**Town of Berlin
Planning Commission**

STAFF REPORT

SUBJECT: Requested Modification to Purnell Crossing Master Plan (Dated November 2025)

SUBJECT: Purnell Crossing PUD Phase 5 - Preliminary 20-Lot Subdivision

SCALE: AS SHOWN NOV 2025 152-02-001

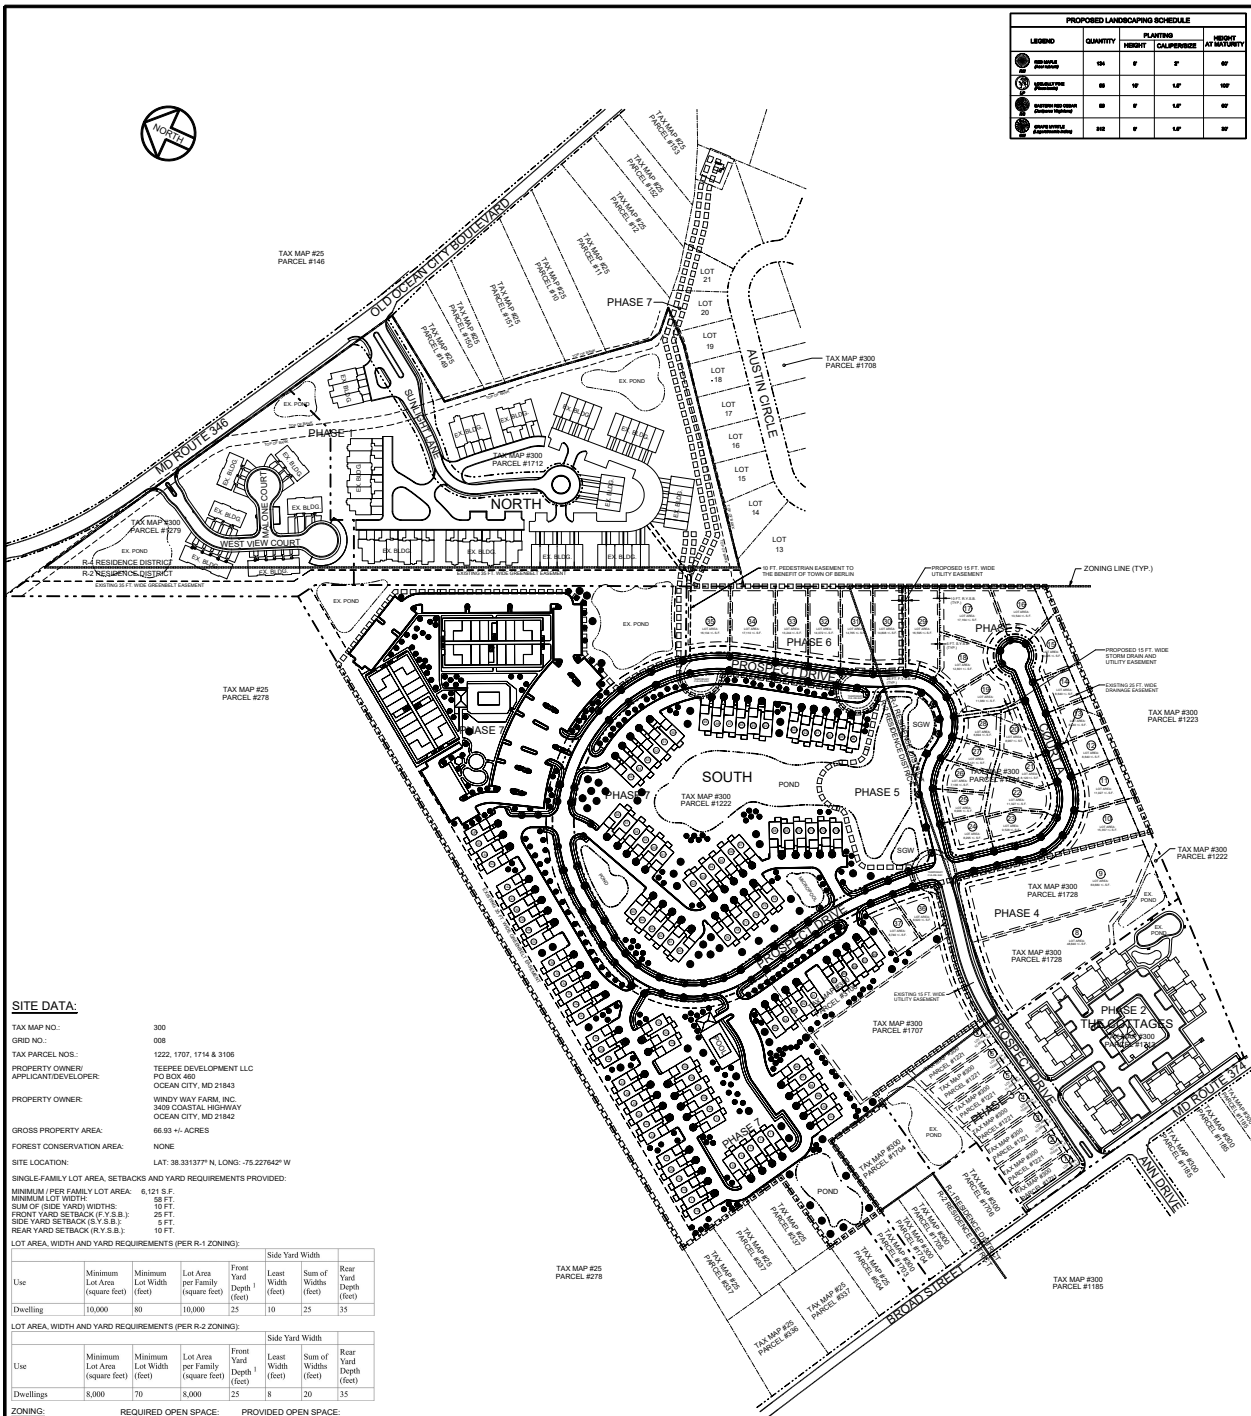
1. **Lot Widths:** The Applicant is proposing lot widths that are less than even the lowest minimum required in the residential zone under the Town Code. The minimum lot width in the R-4 district is 60 feet. The proposed lot widths fall far below this threshold, representing a significant deviation not only from the underlying zoning but also from typical residential development standards.

2. **Rear Yard Setbacks:** Berlin's Town Code standard rear yard setback across residential zoning districts is 35 feet. The applicant is proposing a reduced rear setback of 10 feet. This represents a substantial reduction that may impact privacy, drainage, and overall site functionality, with the possibility of backyards of houses being as little as 20 feet apart.

3. **Side Yard Setbacks:** The underlying zone for Phase 5 is R-1, with each side yard of 10 feet, with a sum of side yards with a minimum width of 25 feet. The minimum side yard setback of any residential zone in Berlin is R-4 district with 6 feet, with a combined minimum of 15 feet between structures. The applicant is proposing a side yard setback of 5 feet with a sum of 10 feet, which is over half of what is required under the existing underlying R-1 zone.

4. **Building Separation and Safety Concerns:** The proposed reductions in side yard setbacks result in residential structures being located in very close proximity to one another. Chapter 108 Article IV allows for the projection of certain features into the setbacks; however, when accounting for building features such as HVAC units, chimneys, and other appurtenances, the effective separation distance between structures may be further reduced.

At this time, staff cannot confirm that the proposed spacing would provide sufficient clearance for emergency access between homes in the event of a fire other emergency.

1. Defer action on requested bulk changes in setback until a fully compliant and clearly justified revised Purnell Crossing PUD Master Plan is submitted.
2. If the Planning Commission is open to providing the “option” for additional reduction of the lot sizes and setbacks, (i) the reductions will be specific to and limited to only Phase 5; (ii) be on a deferred basis to be granted on a lot-by-lot basis within Phase 5 only at the site plan review stage (or, at a minimum, final subdivision approval stage) and (iii) the 2026 Revised Master Plan updated to remove the proposed building restriction lines within Phases 5 and 6 on the Applicant’s 2026 Revised Master Plan before being finalized.
